RE: Comments for Prologis South Park; Application number 201509280070

DEVELOPMENT PLANS FOR PROLOGIS SOUTH PARK

MASTER SITE PLAN C1.00

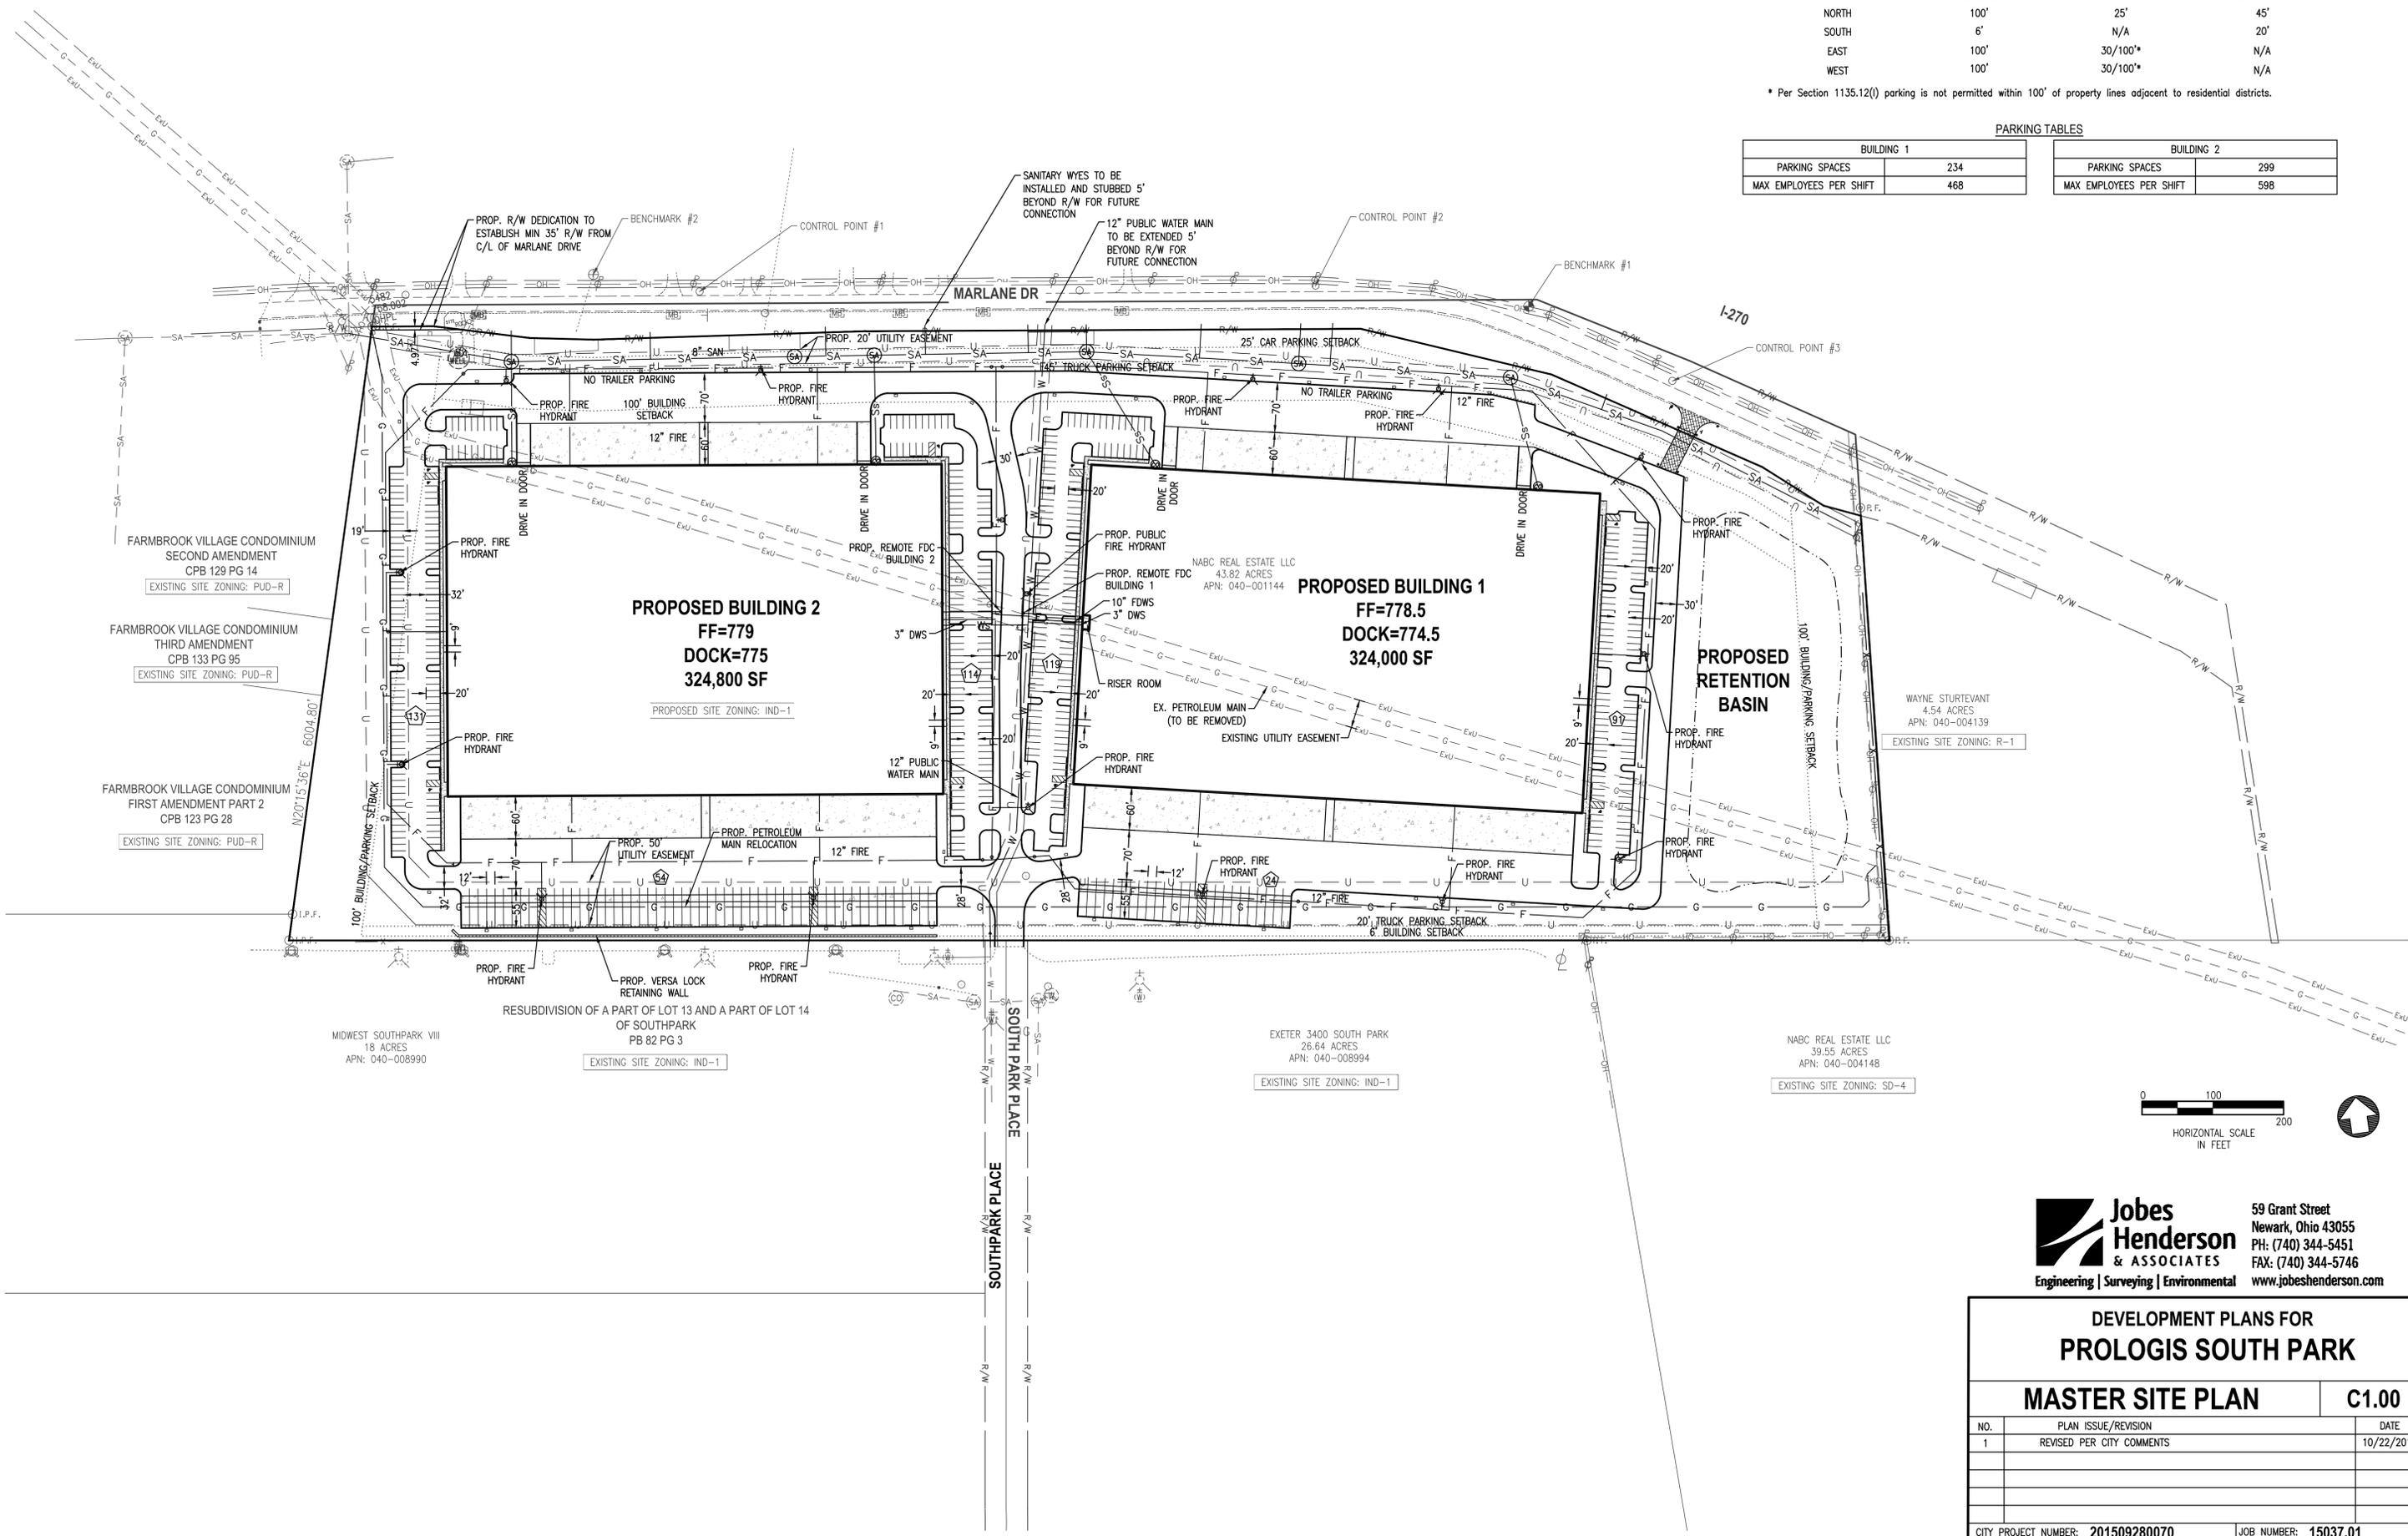
RESPONSE: The curb cut at the center of the site to Marlane Drive has been eliminated. The curb cut at the eastern end of the site is to remain. That access will be signed as emergency access only and will provide the fire department and other emergency personnel access to the site.

10. Parking and building setbacks should be illustrated on all plan sheets. A table showing all required setbacks (building and parking for all four sides) should be included on the Master Site Plan.

RESPONSE: The table has been added.

RESPONSE: The requested information has been added.
14. A note should be added to the building elevations that all rooftop mechanicals will be screened on all sides by raising the building parapet.

GRADING & DRAINAGE PLAN		C3.01
NO.	PLAN ISSUE/REVISION	DATE
1	REVISED PER CITY COMMENTS	10/22/2015
CITY PROJECT NUMBER: 201509280070		JOB NUMBER: 15037.01
DRAWN: AES	CHECKED: AES	DATE: 09/28/2015

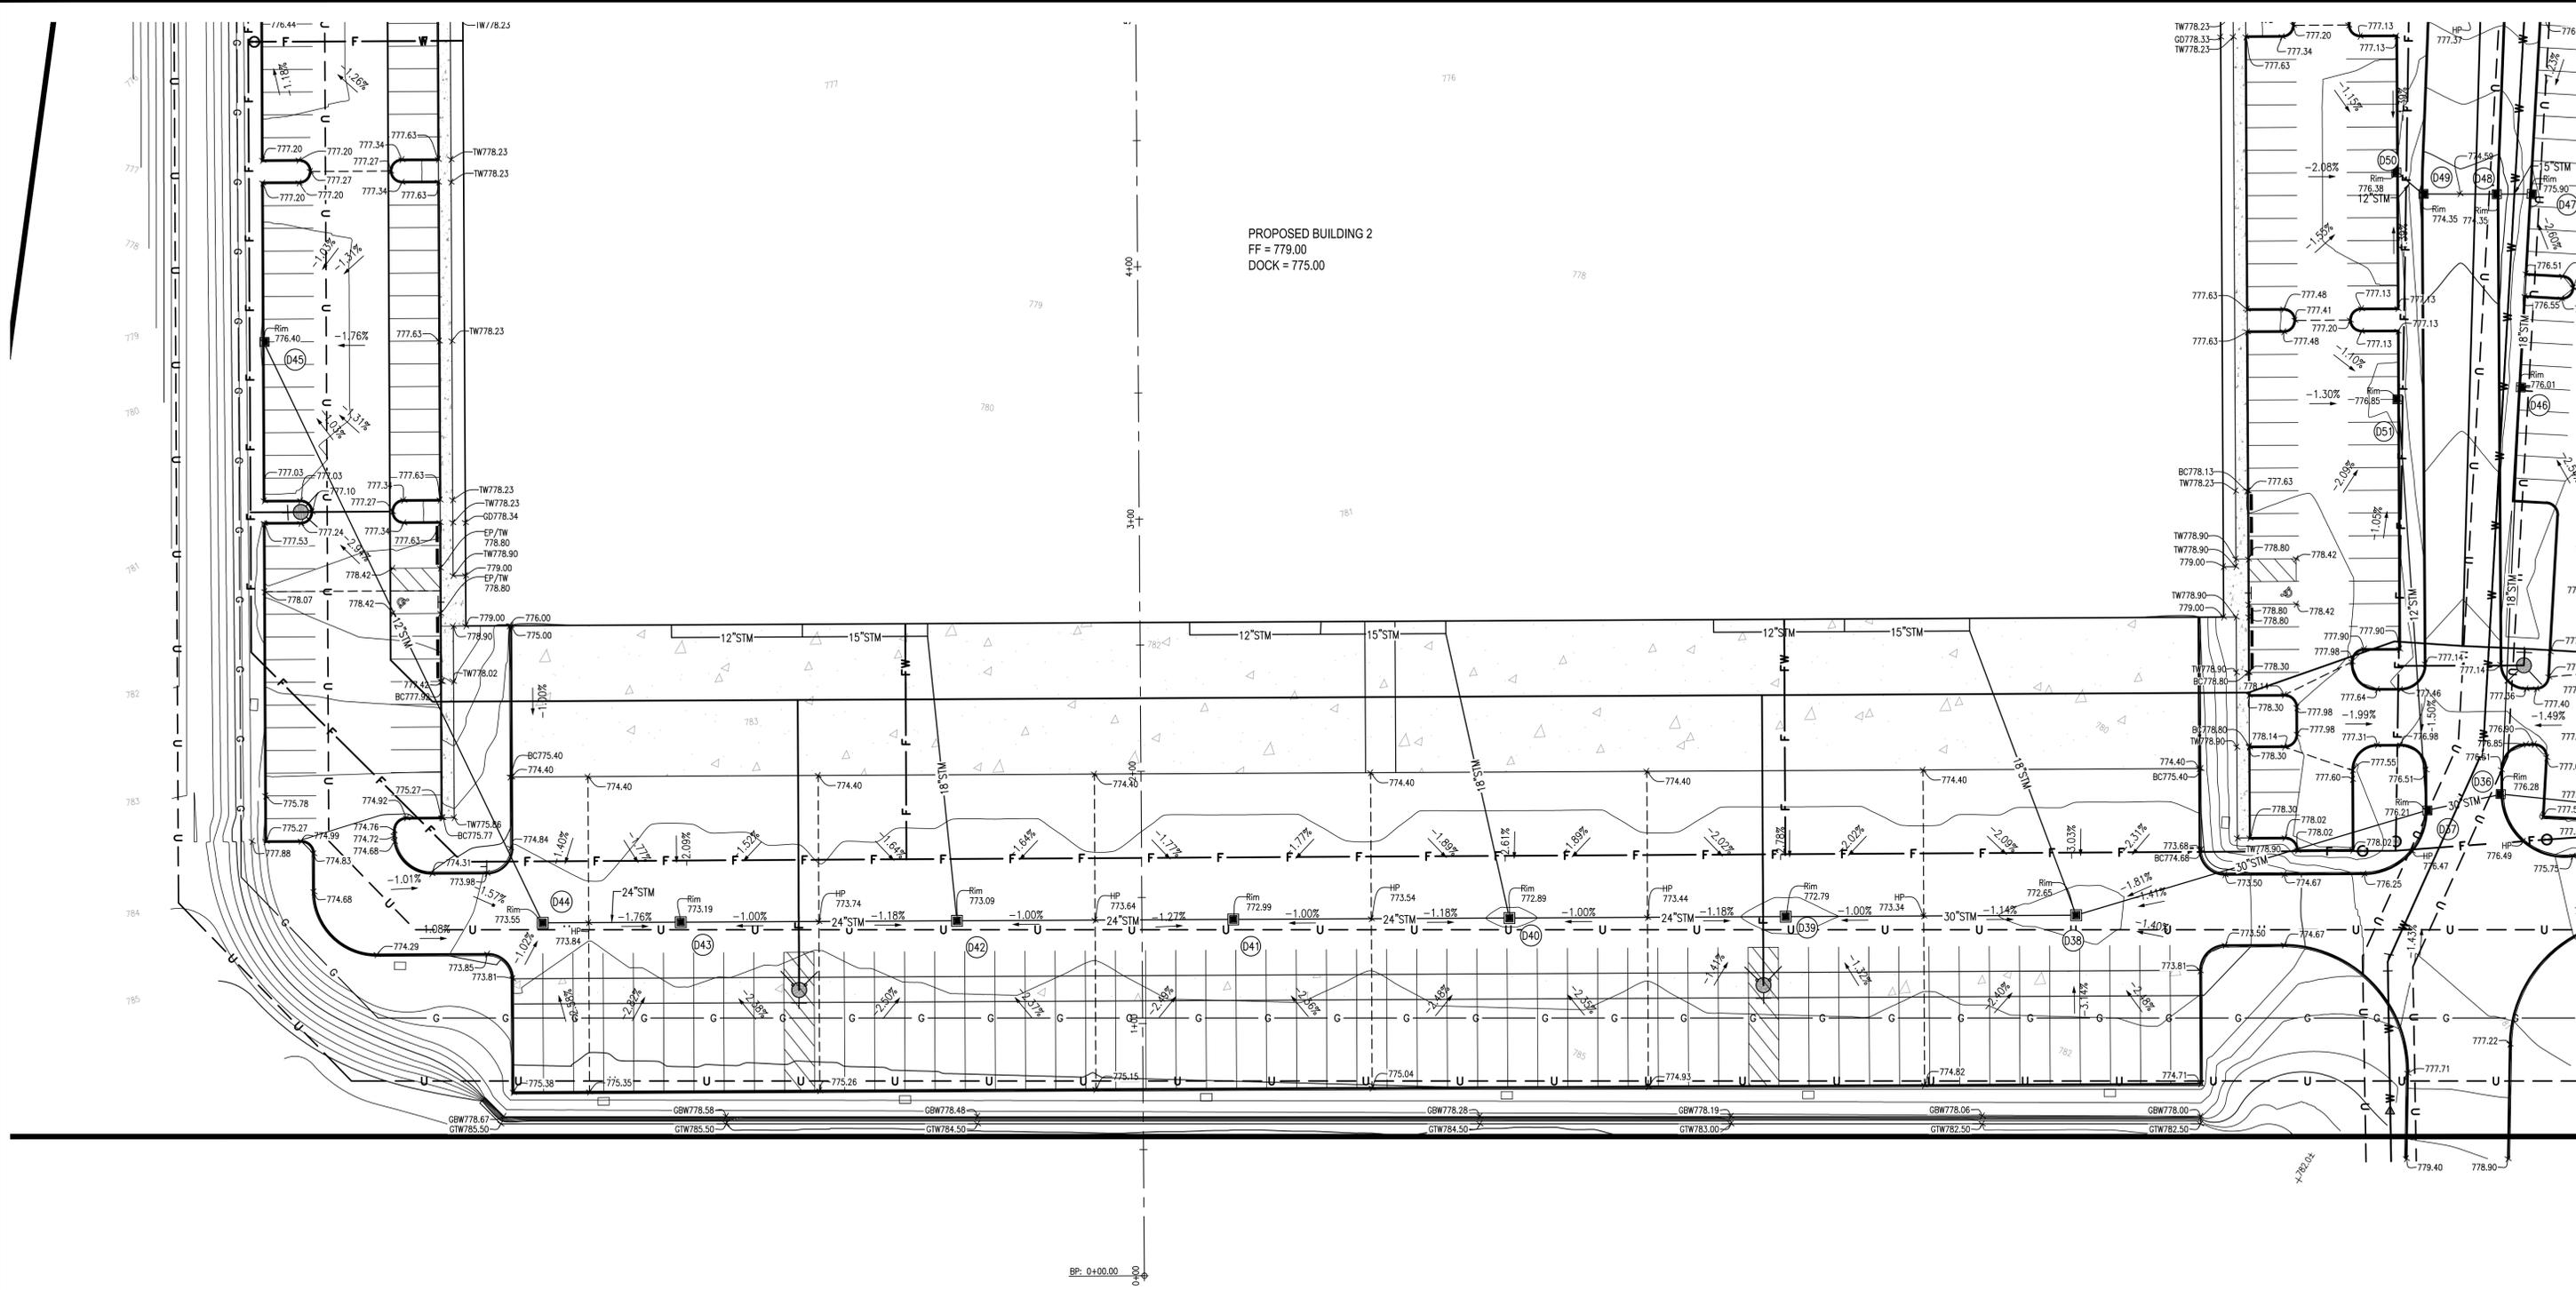
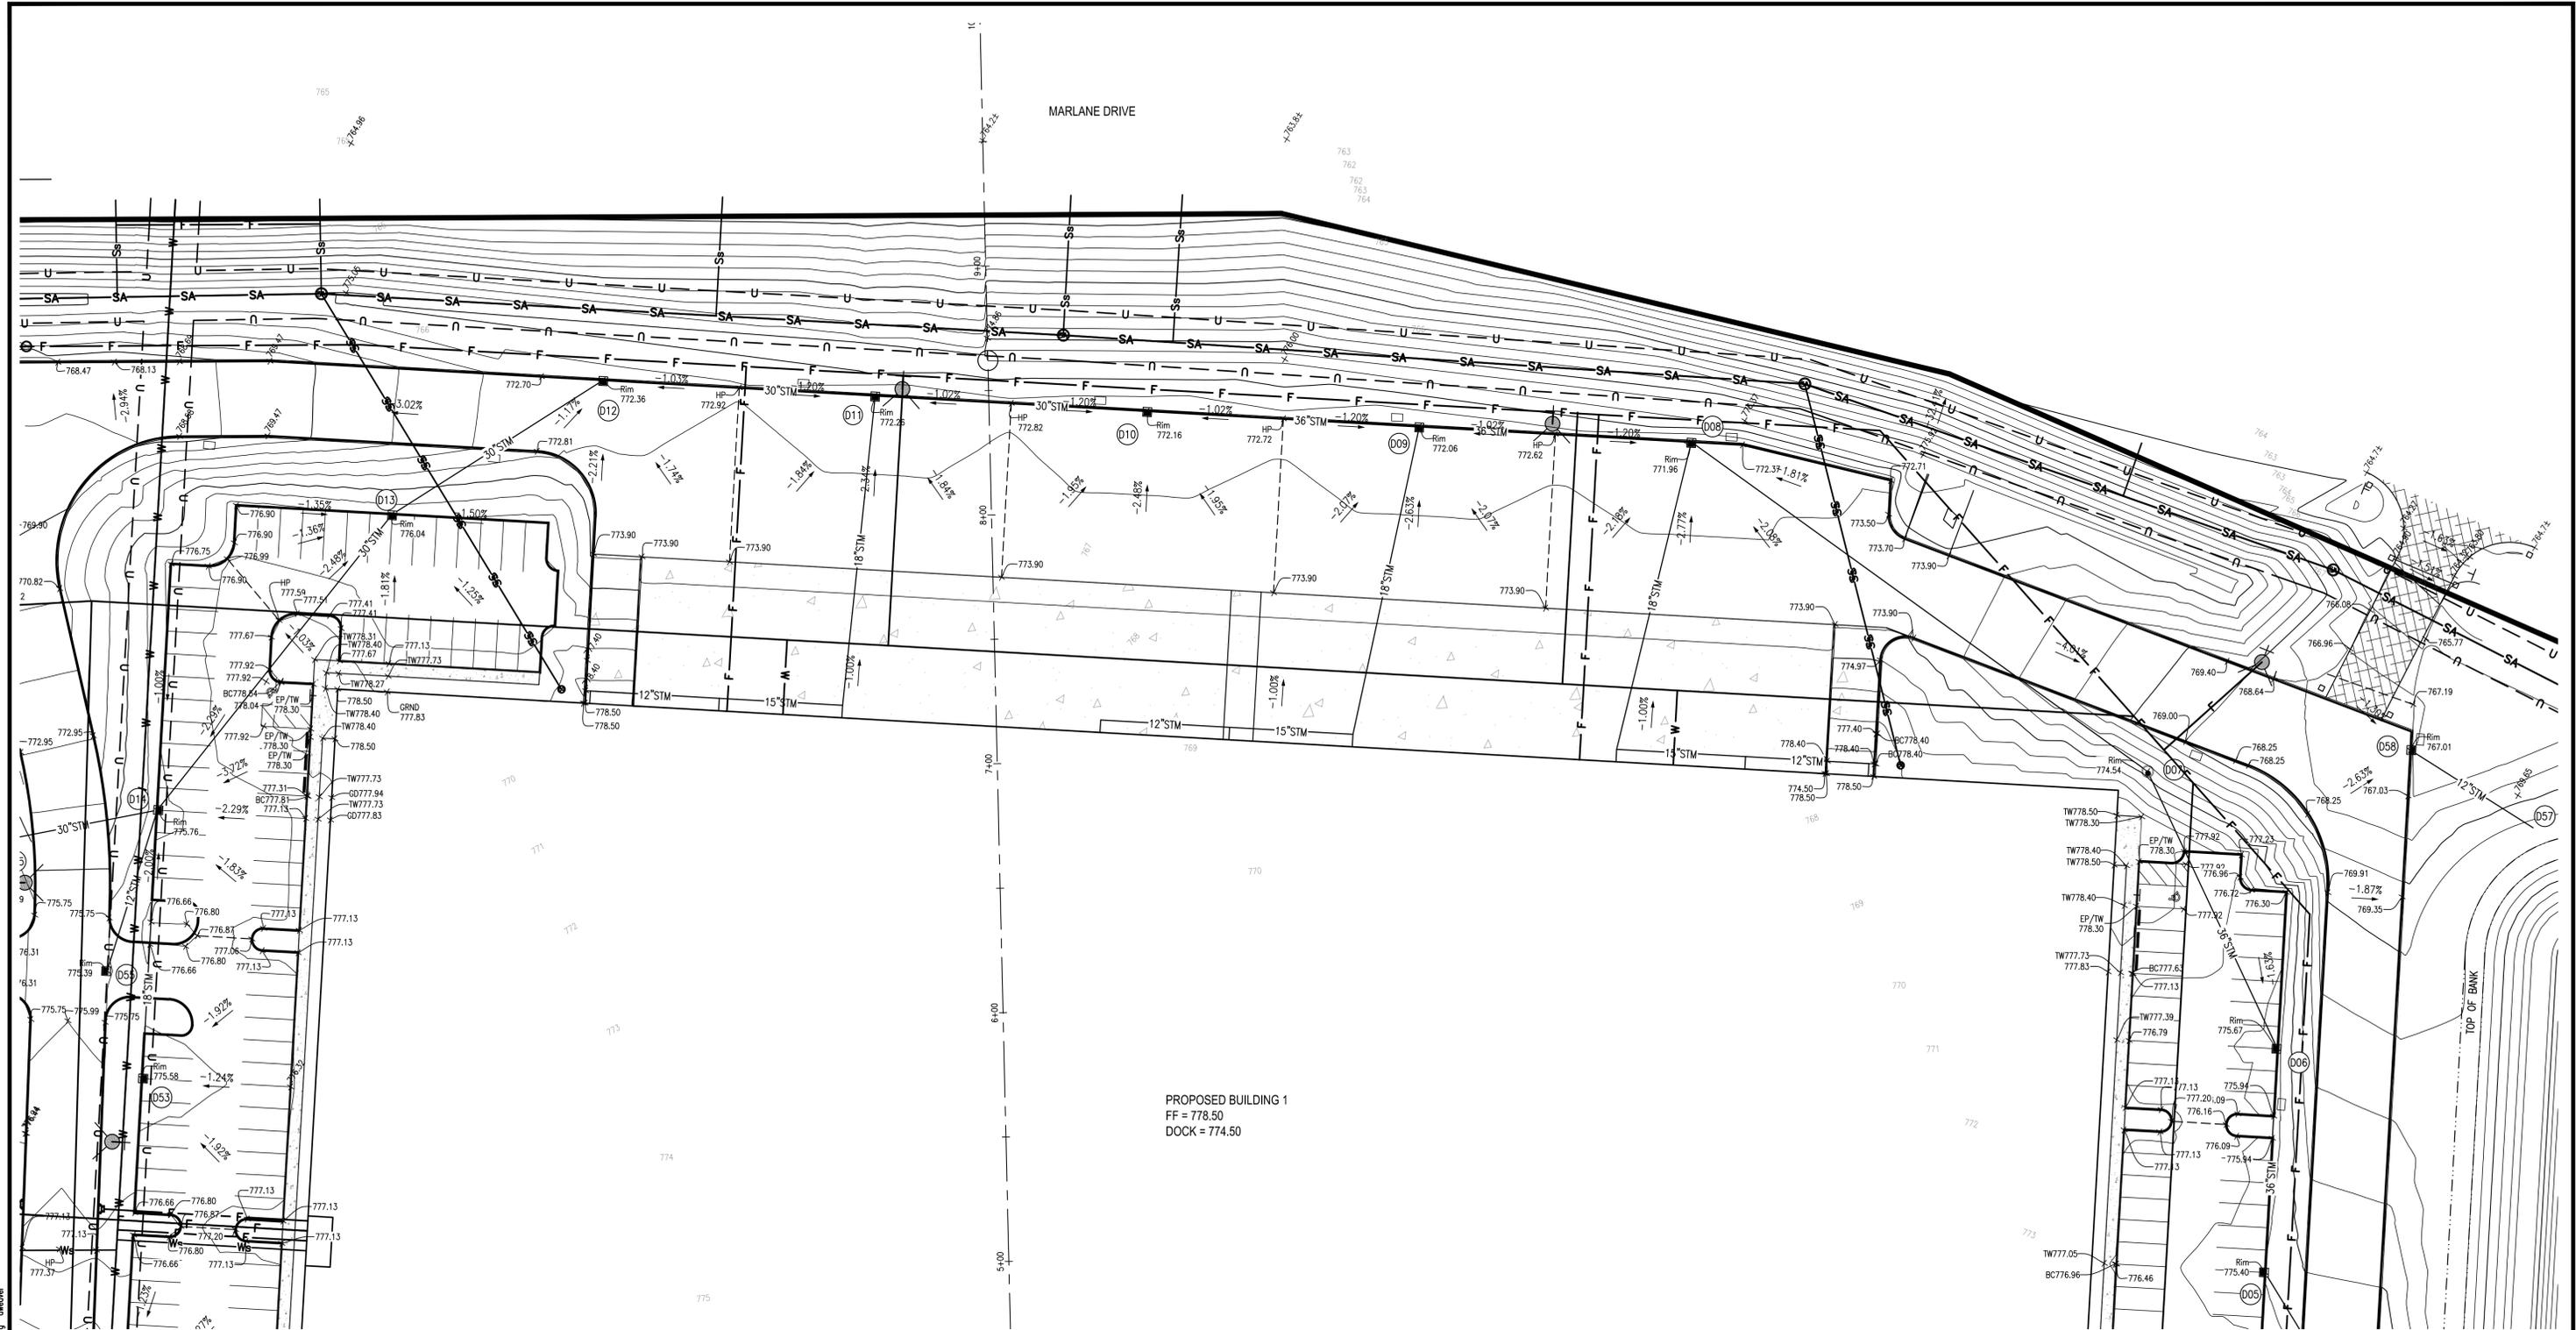
40. Pages C3.01 show "No Truck Access" signs to Marlane Drive – Please show maneuverability for emergency responder vehicles.

RESPONSE: The curb cuts on Marlane have been revised to a single cut for emergency access only.
